## Australian Institute of Architects

To: Department of Planning, Industry and Environment (DPIE) / Reference Western Harbour Tunnel & Warringah Freeway Upgrade EIS Application Number SSI-8863

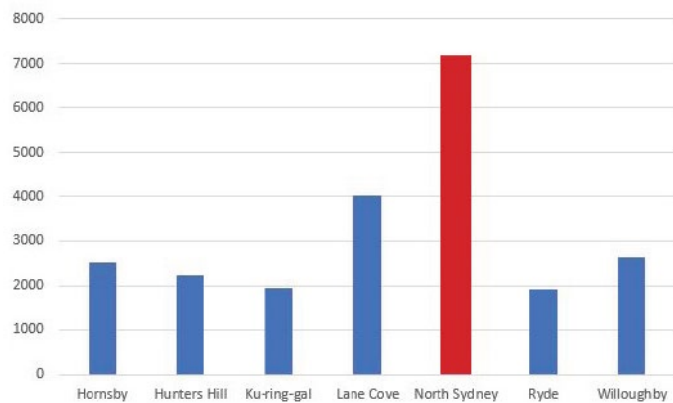
**Problem:** The tunnel extends from Rozelle to Cammeray and is 7.2 kms in length. Note also, the plan is that the emissions from the Beaches Link Tunnel (not part of this EIS) also be discharged unfiltered from this same stack. Furthermore, the additional surface traffic adds to the pollution load. The exhaust stacks at Cammeray are less than 200 metres from the new ANZAC Park Public School.

**Result:** The quality of the air in Rozelle and North Sydney and will be degraded by the emission of pollutants such as carbon monoxide, nitrogen dioxide, hydrocarbon residues and fine particulates. The preservation of good air quality is fundamental and vital to the health of the community. The health of and Rozelle and North Sydney will be adversely impacted by this proposal because of the design of the in the tunnel ventilation system and the location of the emission stacks.

<b>Recommendation:</b>
The proposal should examine what opportunities exist to improve the situation if the project adopts this position. The objective should be to ensure that pollution should be no worse than would be the case without this project.
As <i>Conditions of Approval</i> , we recommend: <ol style="list-style-type: none"><li>1. The installation of transverse ventilation during construction. Tunnels in Madrid, Tokyo and Stockholm are precedents.</li><li>2. Alternately install filtration technology in the stacks, compliant with International Best Practice. The recently completed Central-Wanchai bypass tunnel in Hong Kong is a precedent.</li><li>3. That diesel heavy vehicles be banned from using this tunnel, as is the case for other tunnels over 4.5 kms in length (Examples are the Paris Duplex Tunnel and Istanbul's Eurasia Tunnel).</li></ol>
